Re:	PC #:	B1103915
	Commercial Plan Review Dated:	8.17.11
	Project Name:	Chase – CPC Alton
	Address:	1801 Alton Road
	Occupancy:	B

(Revision 3, PLAN REVIEW COMMENTS, dated 04-22-2013)

JPM CHASE - Alton Road
CPC Interior Renovations
1801 Alton Road
Miami Beach, FloridaEXIT 2
3'-0"
(34" CLEAR)0 4' 8' 16'
SCALE: 1/8" = 1'-0"AREA OF
WORK
FURNITURE
ONLYAREA OF
WORKEXIT 2
6'-0"
(68" CLEAR)AREA OF
WORK

ELEVATION AT BACK OF TELLER LINE

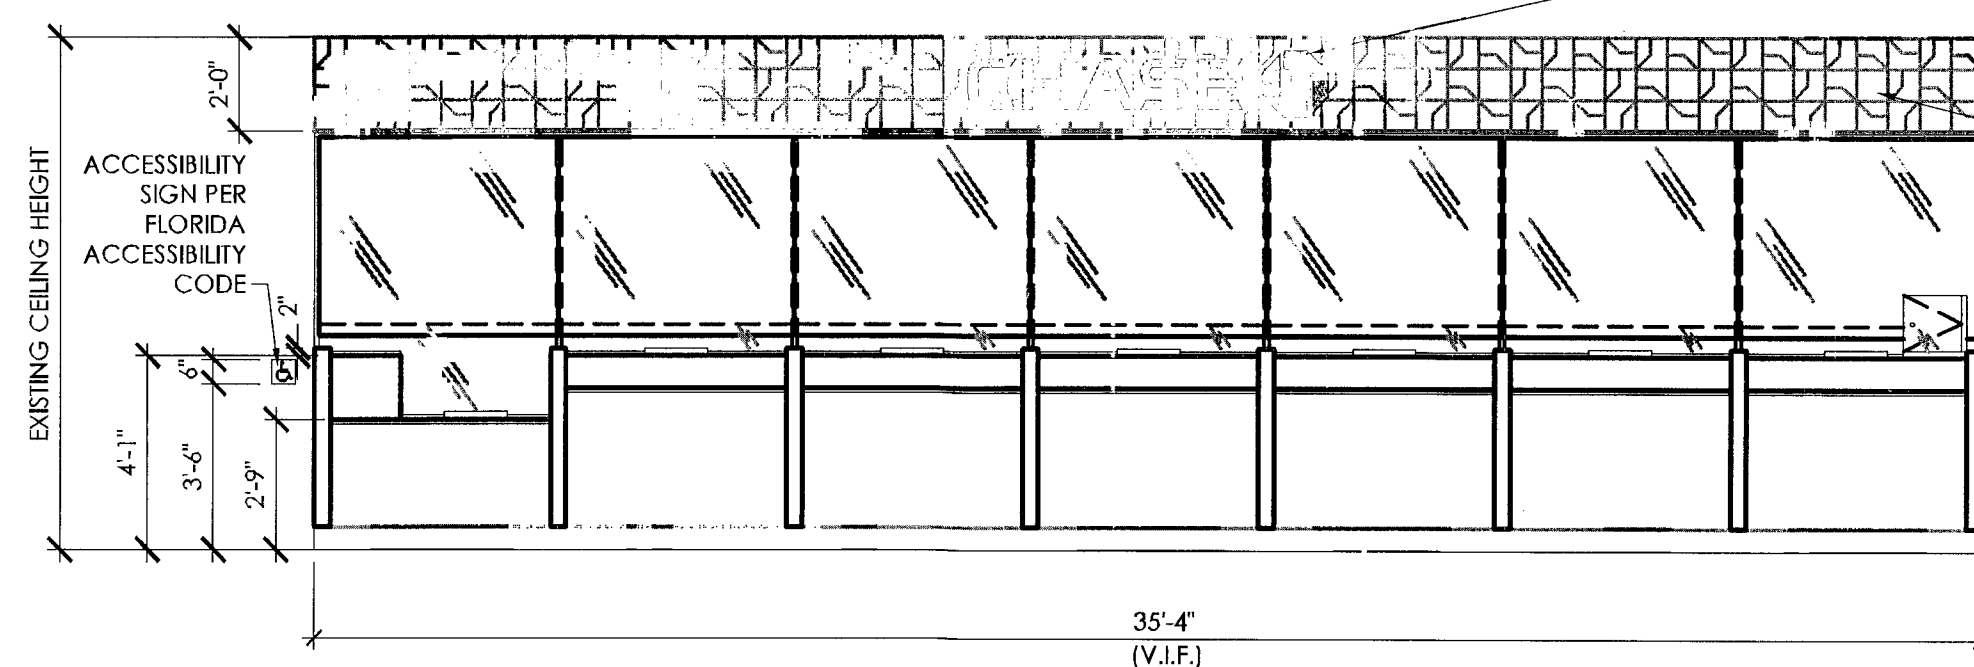
8. **Elevation 1/A5.1: Provide accessibility sign to comply with FAC §216.**

9. **Elevation 1/A5.1: Provide length of accessible teller counter, 36" minimum, to comply with FAC §904.4.**

RESPONSE: Please refer to attached revised sheet A5.1, detail 1, for requested detail.

RESPONSE: Please refer to attached revised sheet A1.2, detail 2 for requested information.

FLOOR PLAN - LIGHTING

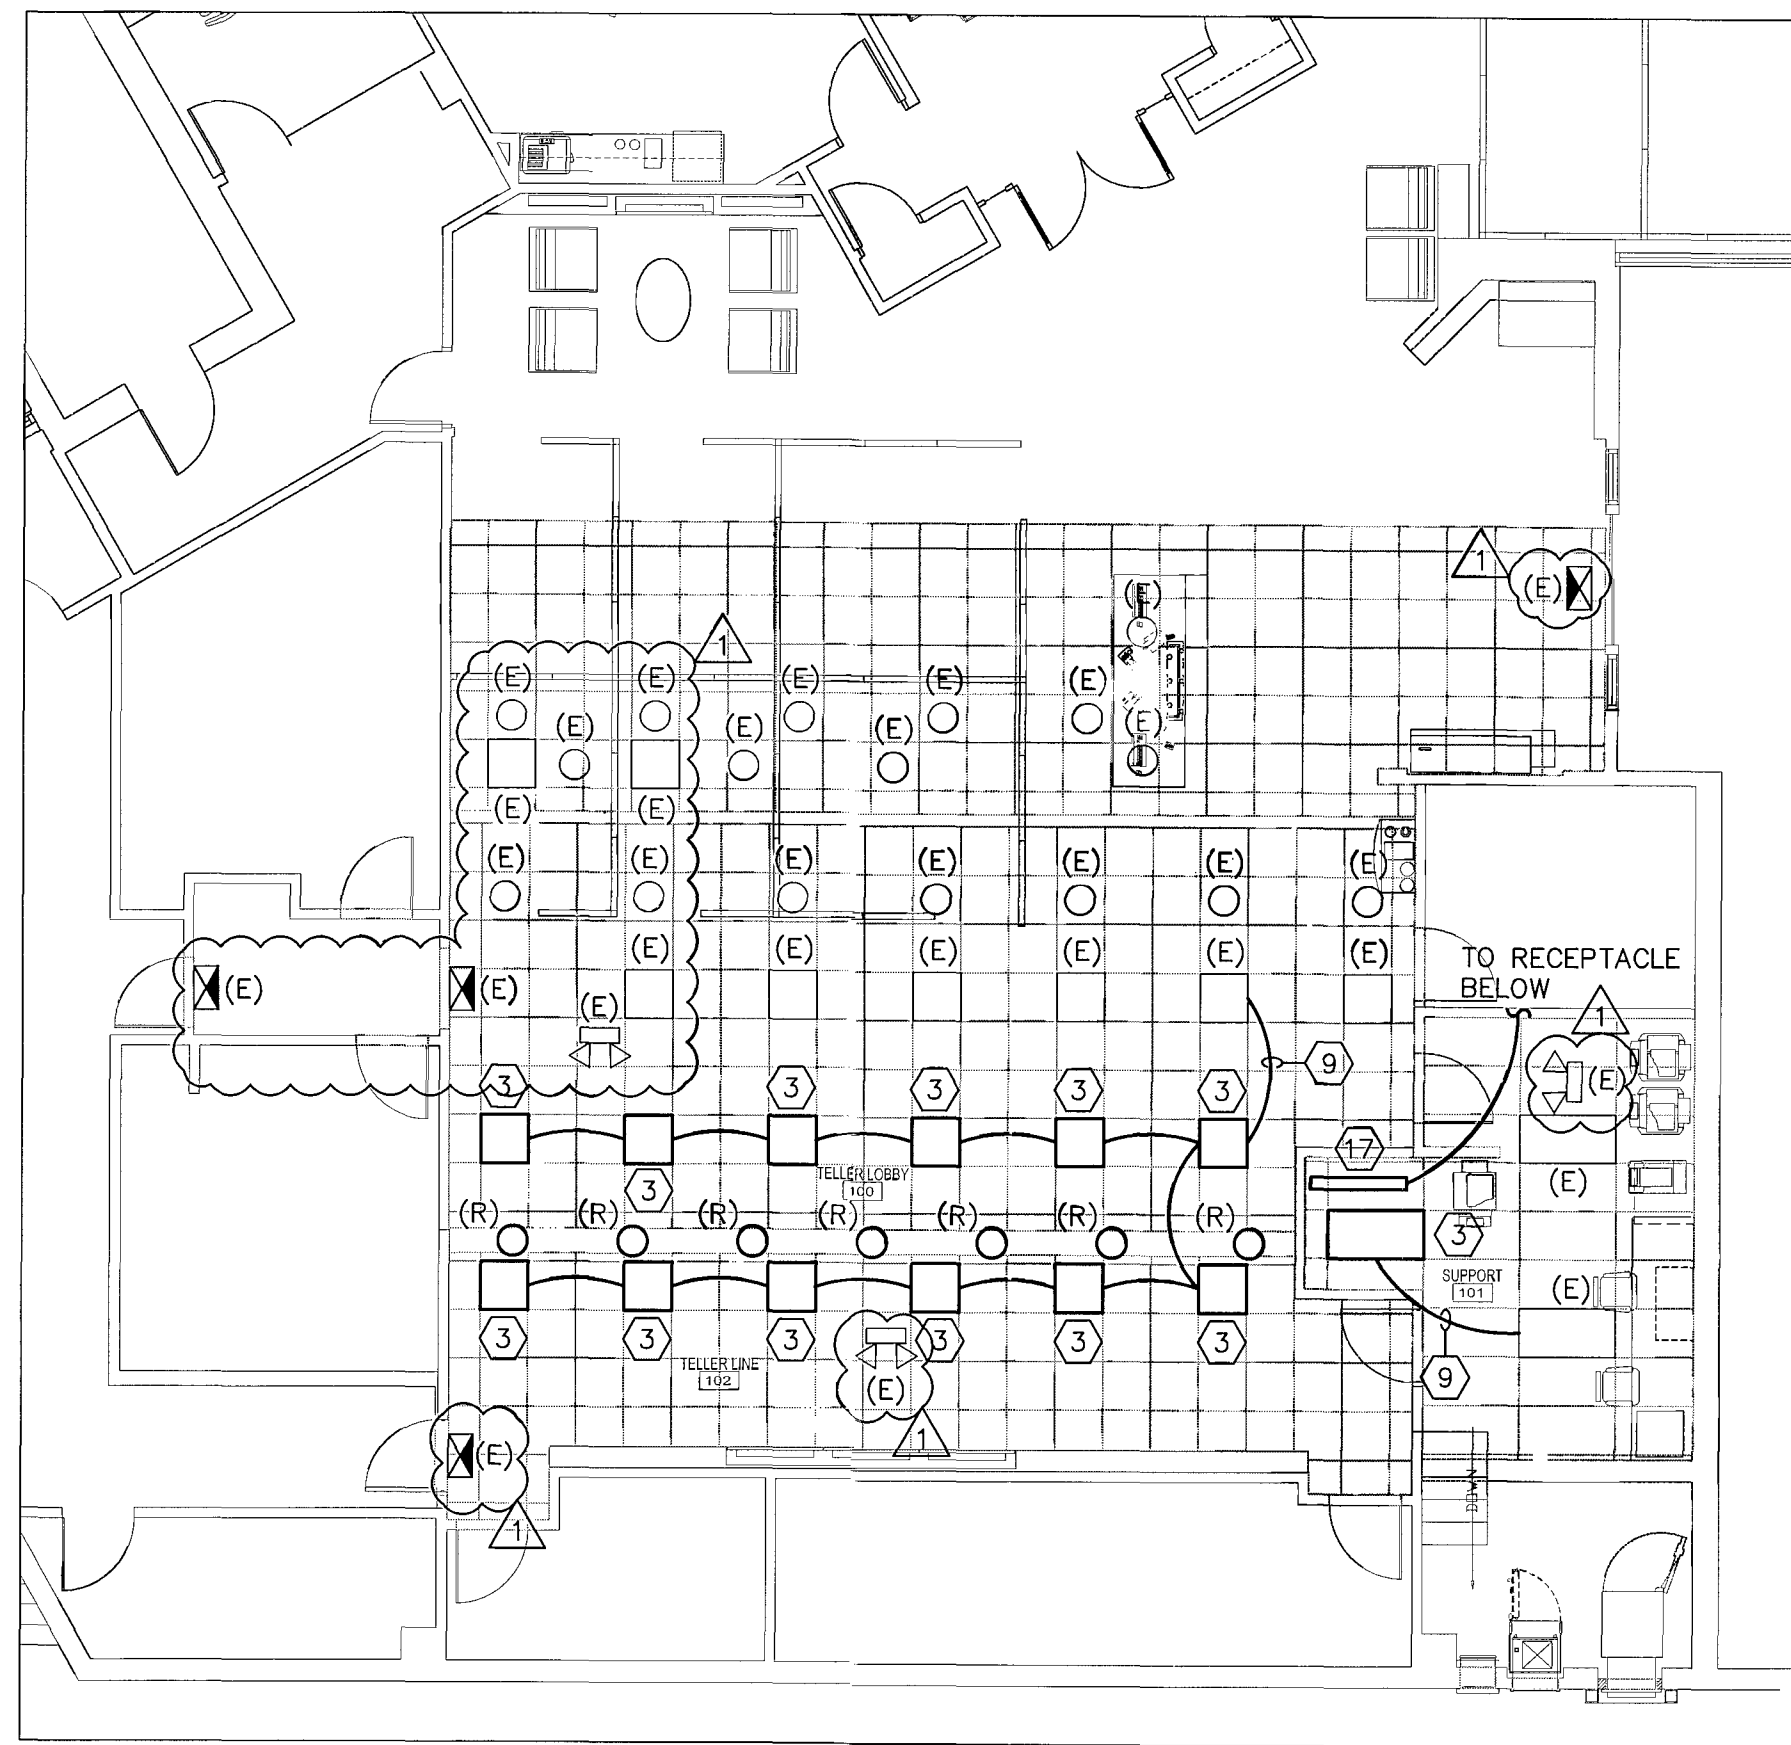
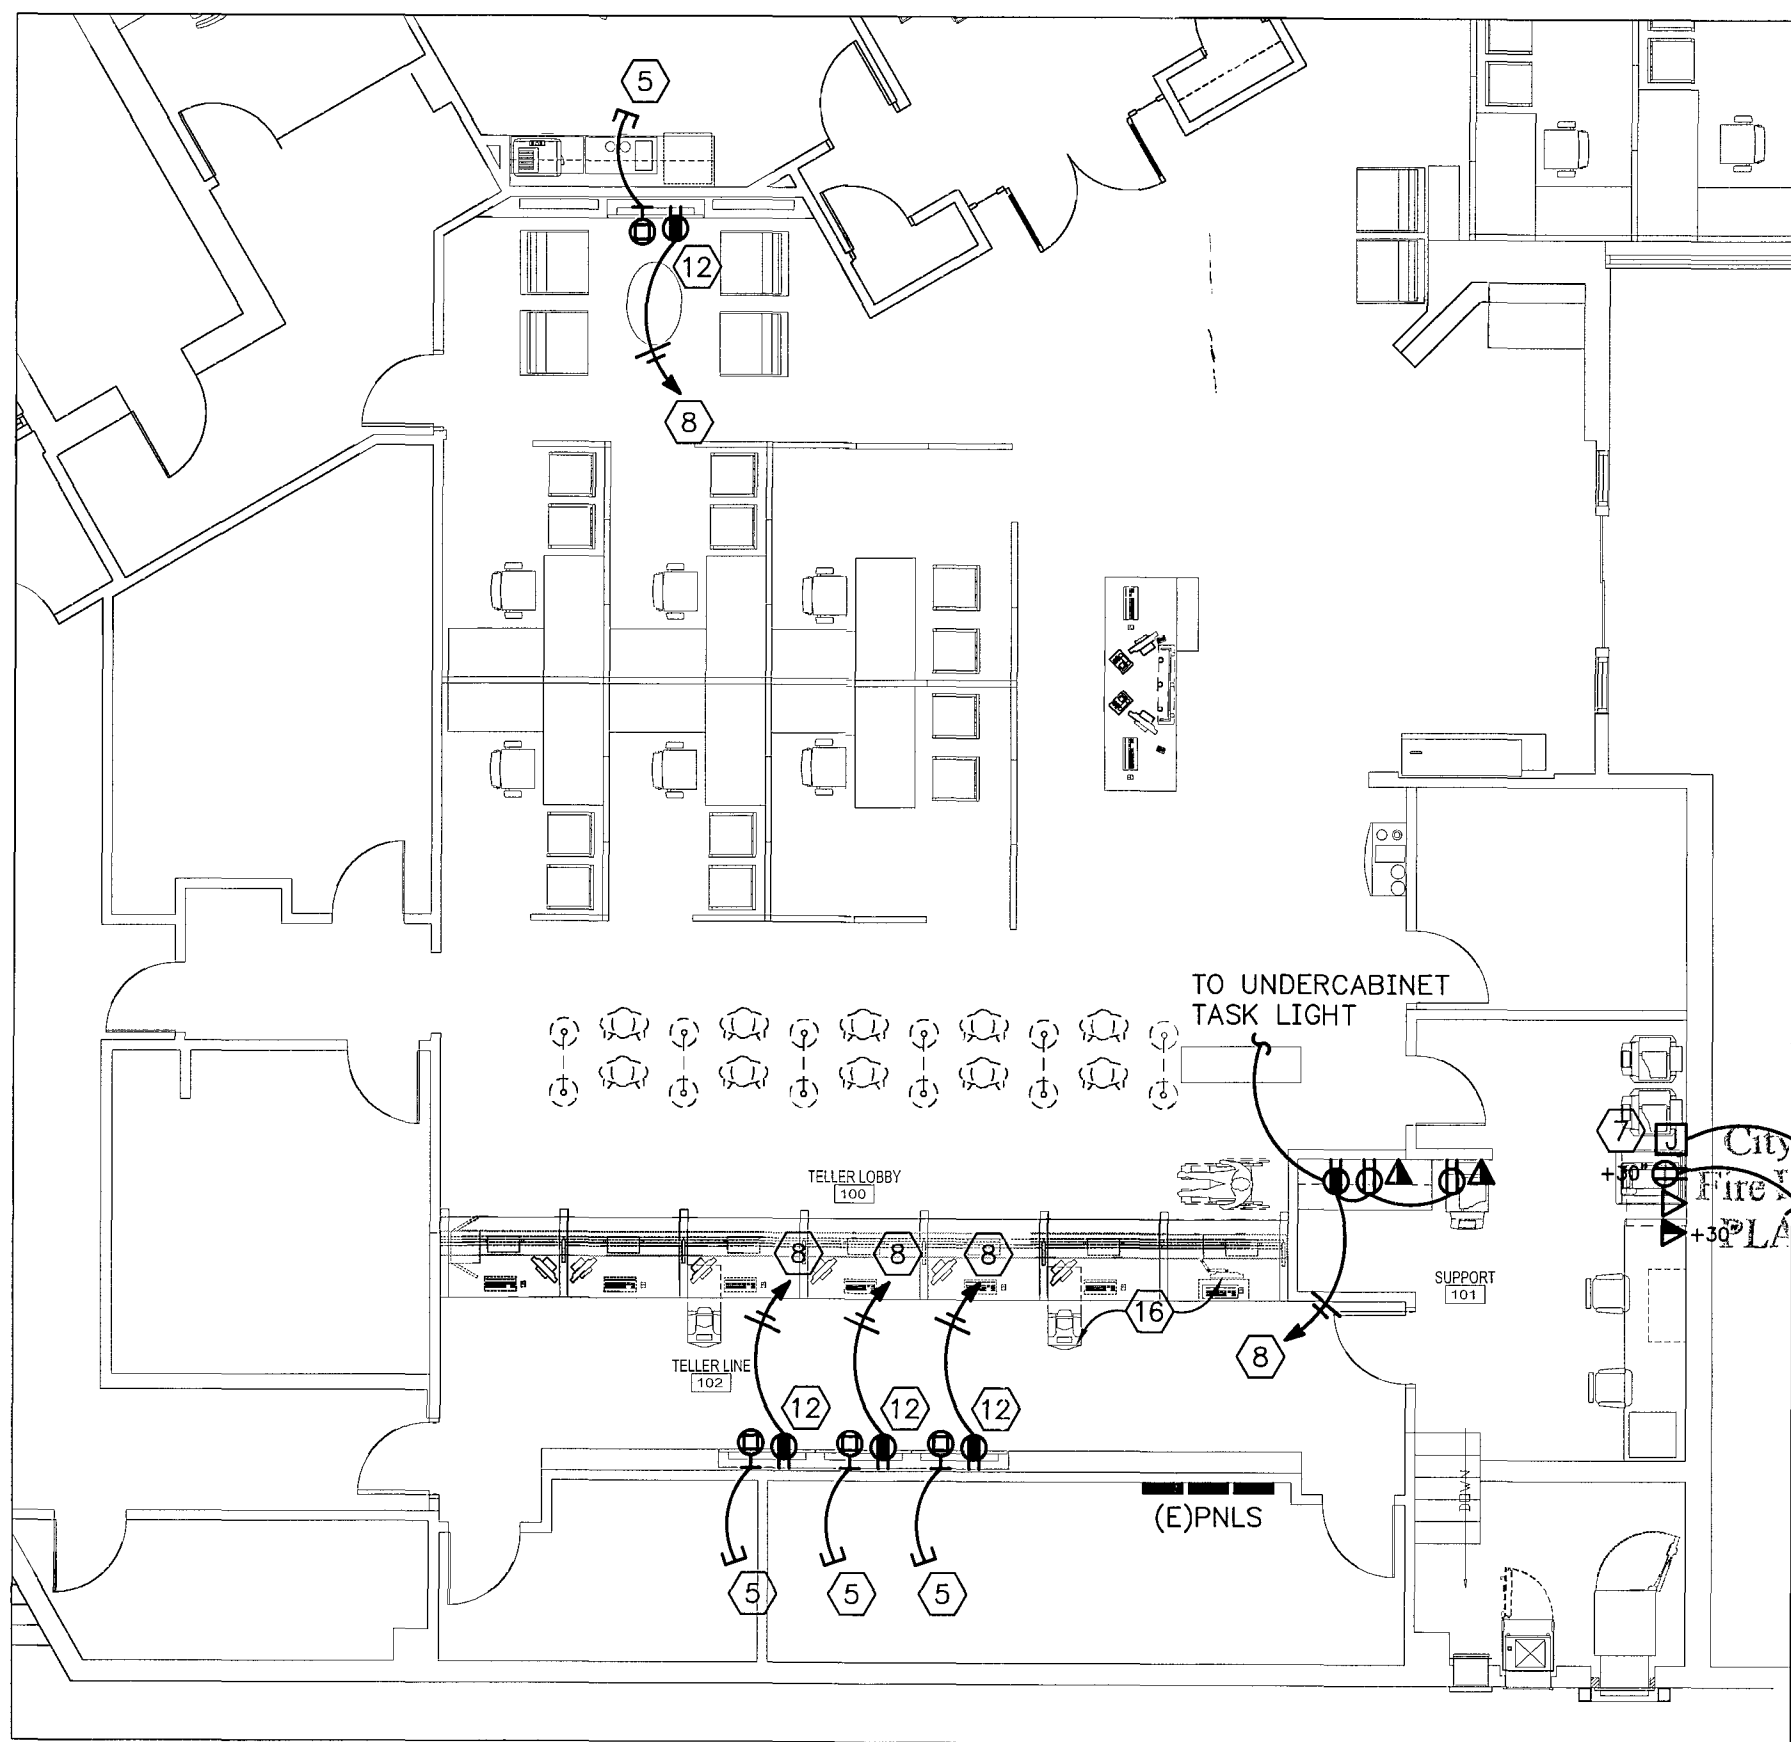
8. Label all areas sheet e100: 1. show location of emergency lights and exit signs, clarify if these items have battery backup rated for 90 min note once the architect/engineer answers the comments additional comments may follow.

RESPONSE: Please refer to the attached revised sheets A1.1 (reflected ceiling plan) and E100 for locations of emergency lights within the area of work. Areas have been labeled on sheet E100.
